RAI: Volume 3, Chapter 2.2.1.3.1, Number 1:

RAI: Volume 3, Chapter 2.2.1.3.1, Number 2:

RAI: Volume 3, Chapter 2.2.1.3.1, Number 3:

RAI: Volume 3, Chapter 2.2.1.3.1, Number 5:

Figure 1. Drip Shield Framework Failure Times for the TSPA-LA Base Case and the Alternate Case

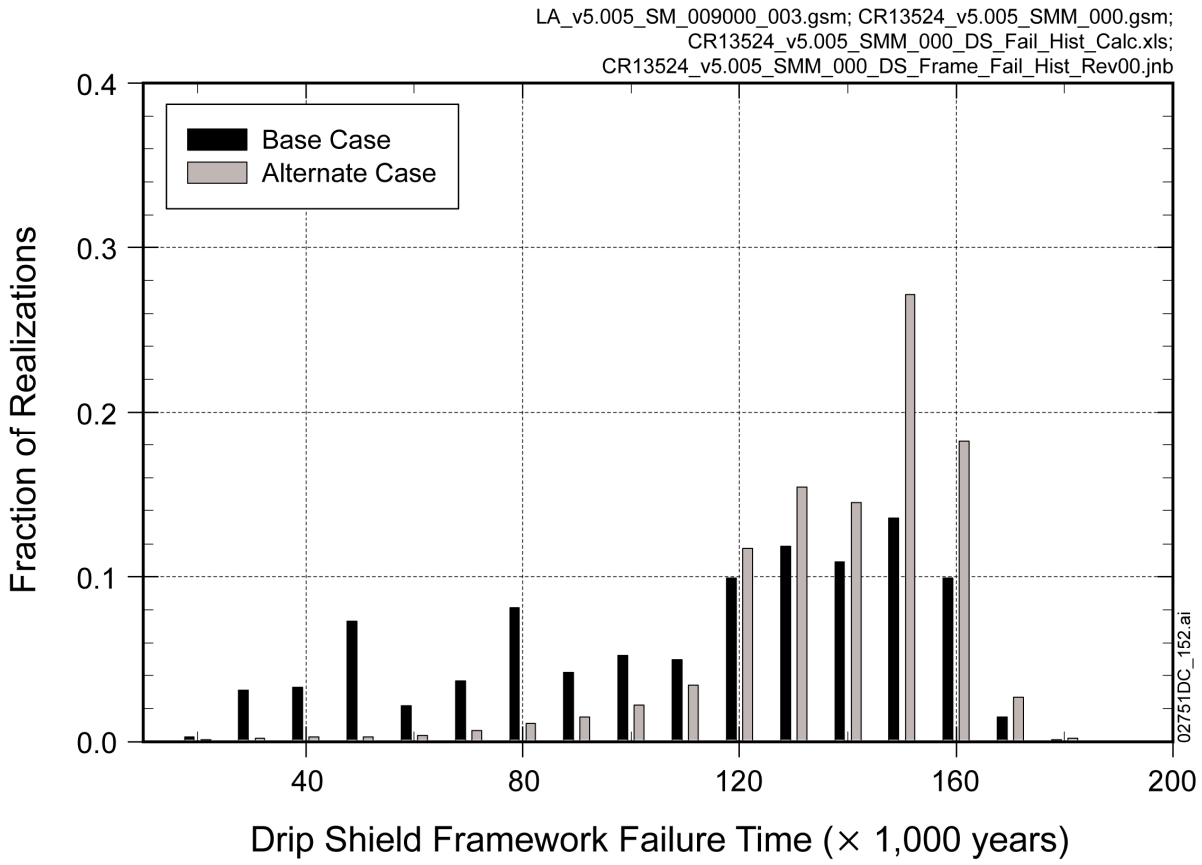
Part 1: Provide a technical basis to support the extrapolation of general corrosion rate ratios (developed from 42-day weight-loss test data) of titanium Grade 29 to Grade 7 to the repository performance period, given the metallurgical differences between the two metals.

Figure 1 compares the distribution of the time of drip shield framework failure between the TSPA-LA base case and the alternate case in which the general corrosion rate of Titanium Grade 29 was set equal to that of Titanium Grade 7. Figure 1 shows that framework failure occurs later in the alternate case due to the slower rate of general corrosion. Figure 2 compares the distribution of expected annual dose for the seismic ground motion modeling case for the two cases. Despite the change in time of drip shield framework failure, the timing and magnitude of expected annual dose for each realization, and the range of uncertainty among realizations, are similar for both cases. Figure 3 compares statistics for the distribution of expected annual dose between the two cases. Except for slight increases between 80,000 and 160,000 years postclosure, the mean annual dose is essentially unchanged between the base case and the alternate case. Between about 80,000 and 300,000 years postclosure, the median annual dose is roughly 25% greater in the alternate case than in the base case; slight increases are also observed in the 5th percentile. These increases are due to the increased likelihood of seismic damage to waste packages, as described above. However, the relatively small contribution of the seismic ground motion modeling case to total mean annual dose during these time periods (SAR Figure 2.4-18b) confirms that modeling titanium corrosion rates as equal for

both grades has a negligible effect on the results of the performance assessment for the license application.

Figure 2. Distribution of Expected Annual Dose in the Seismic Ground Motion Modeling Case for (a) TSPA-LA Base Case and (b) Alternate Case

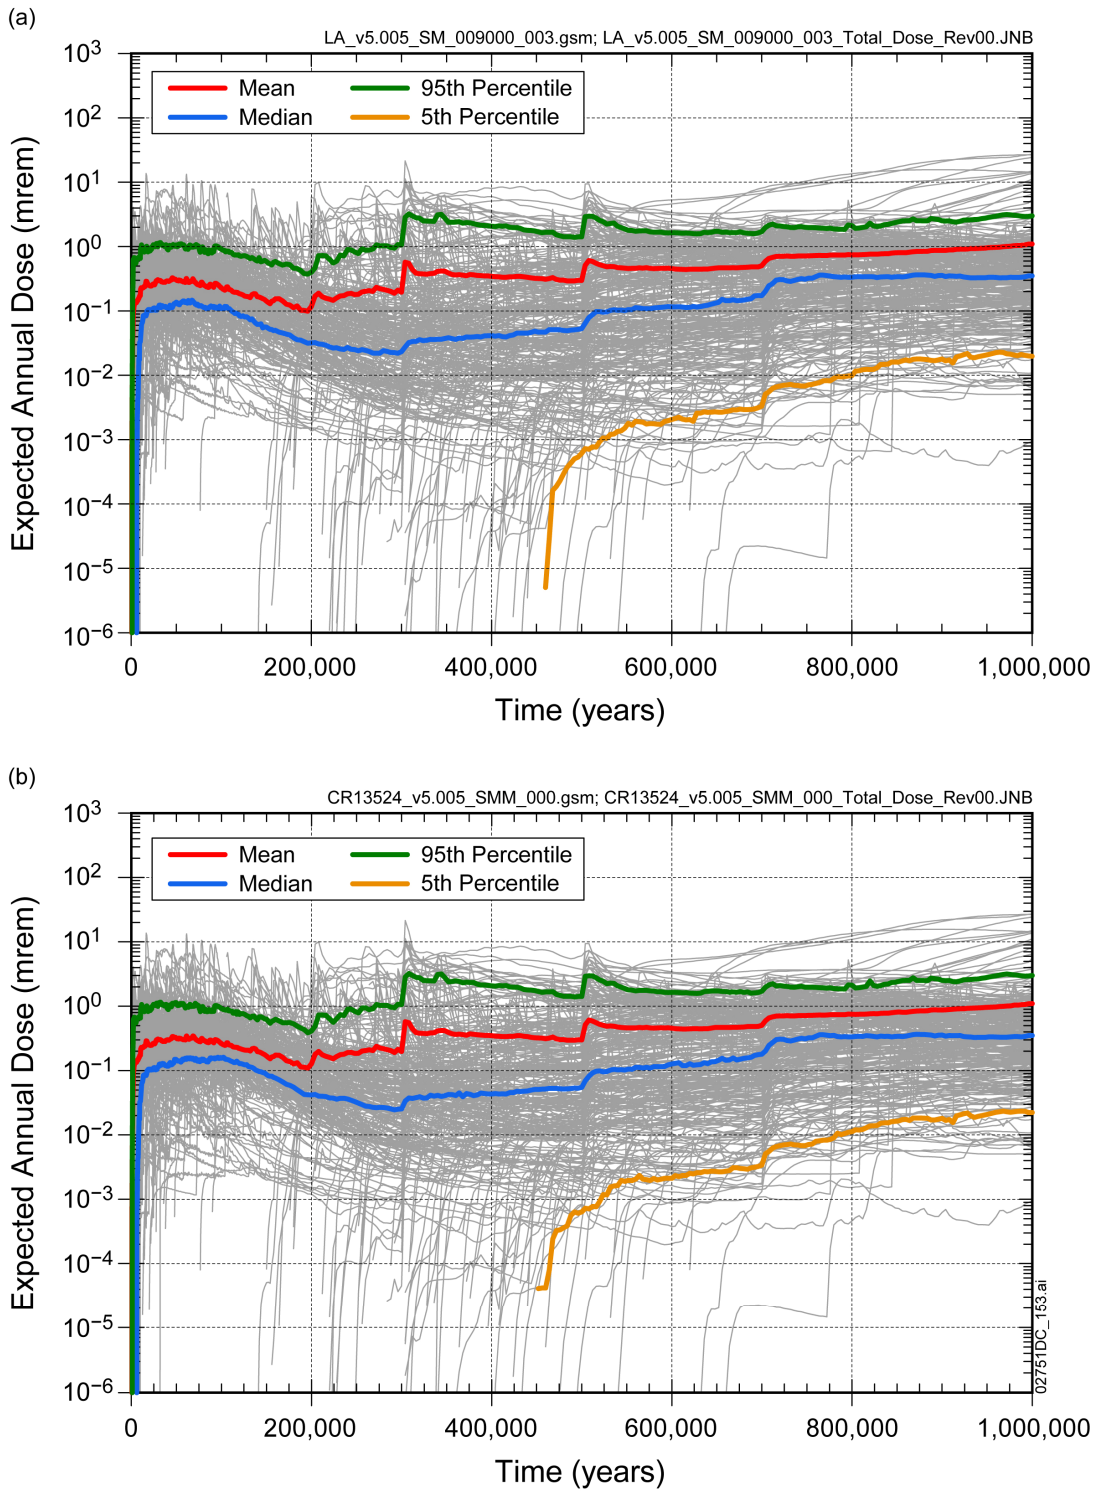
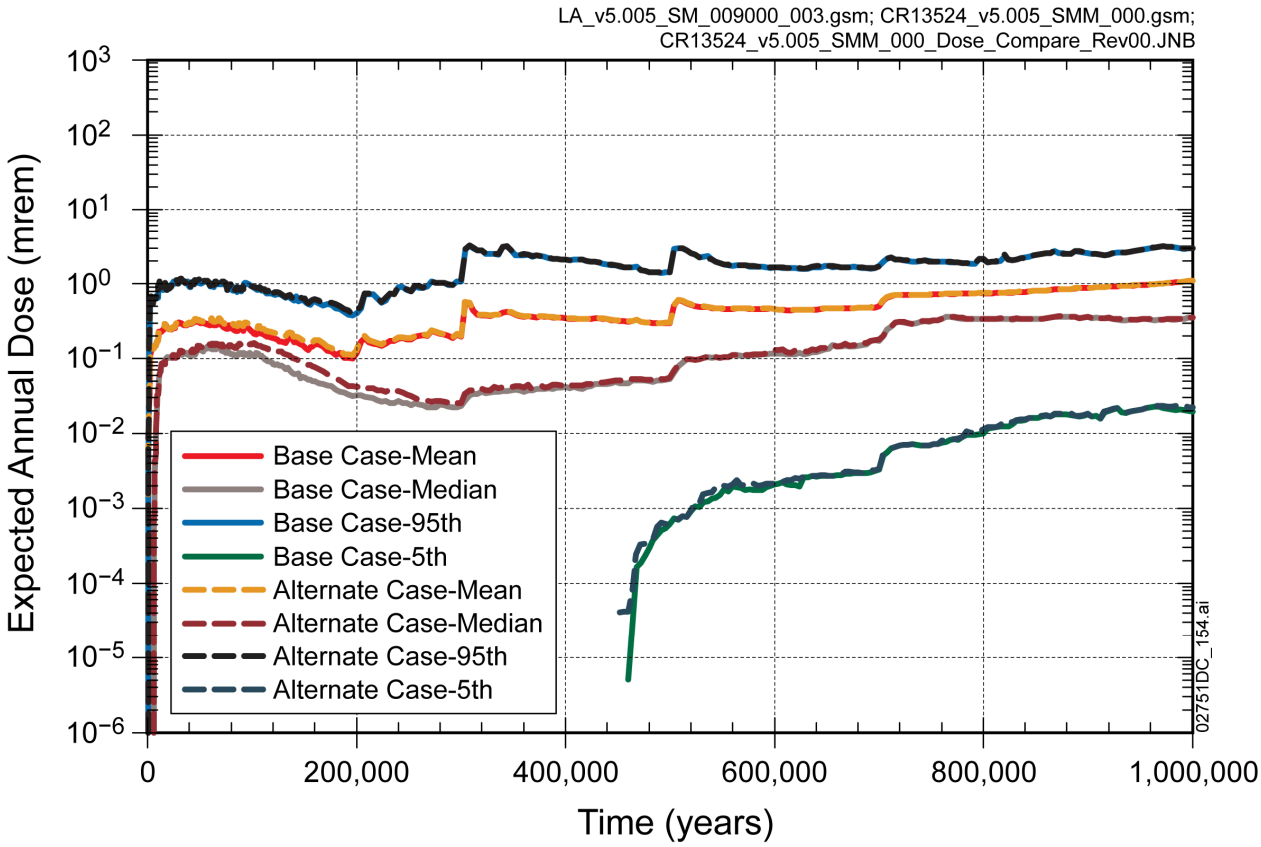
Part 2: Explain how uncertainty resulting from different metallurgical compositions in titanium Grades 7 and 29 is propagated through the performance assessment.

Section 1.1 concludes that it would be more appropriate to model general corrosion rates as equal for both grades of titanium. Based on the sensitivity analyses presented above, modeling corrosion rates as equal may result in an increase in expected annual dose in the seismic ground motion modeling case between about 80,000 and 300,000 years postclosure, as indicated by the sensitivity analysis results. To quantify the potential increase in the expected annual dose that results from modeling titanium corrosion rates as equal for both grades, an impact assessment was performed with the TSPA-LA model. In the impact assessment, the general corrosion rate of Titanium Grade 29 was set equal to that of Titanium Grade 7. No other change to the TSPA-LA model or its input data was made for the impact assessment.

Figure 1. Comparison of Drip Shield Plate Failure Time for the Base and Alternate Cases

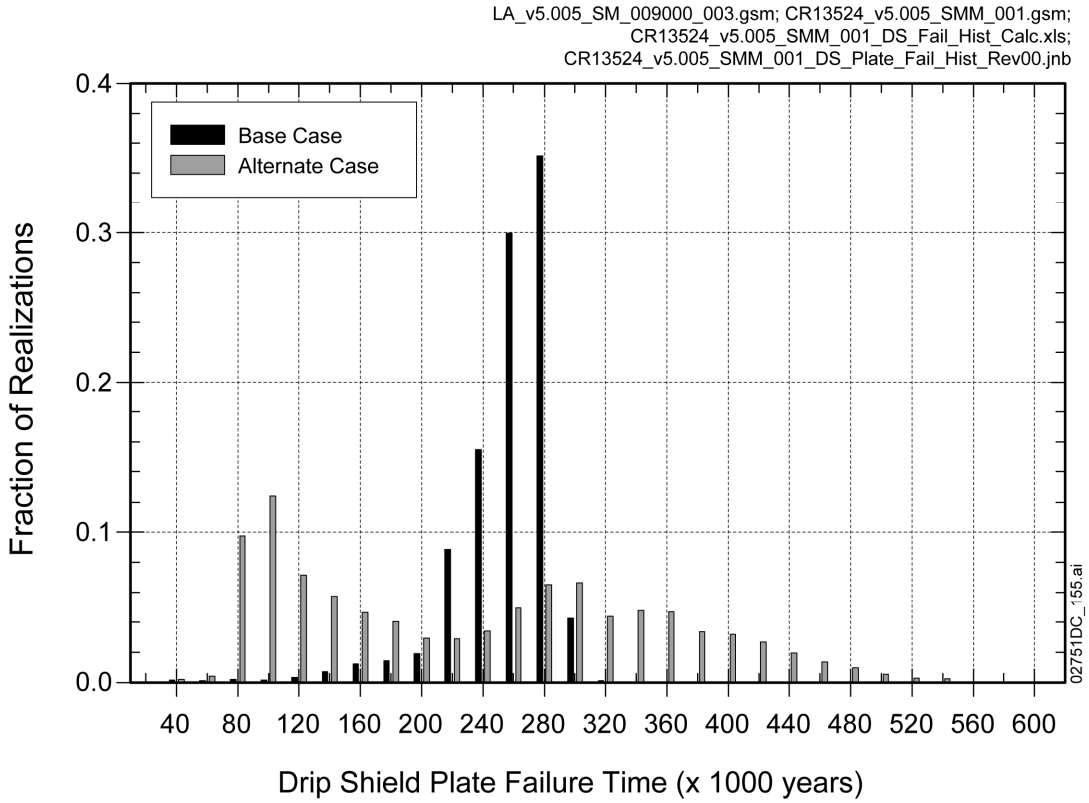
Demonstrate that using conservative assumptions for assessing drip shield corrosion performance in the nominal scenario does not underestimate the effects of drip shield stability on enhancing waste package damage in the seismic scenario.

Figure 1 compares the distributions of failure time for the drip shield plates in the TSPA-LA model and in the alternate case. The figure demonstrates that applying the uncertain multiplier to the Titanium Grade 7 corrosion rates results in both earlier and later drip shield plate failures, as evident in the bimodal appearance of the histogram in the alternate case. Figure 2 compares the distributions of expected annual dose to the RMEI (where the expectation averages over uncertainty in the occurrence and extent of seismic events) for the base and alternate cases. Despite the wider variability in the time of drip shield plate failure, the timing and magnitude of expected annual dose for each realization, and the range of uncertainty among realizations, are similar for both cases.
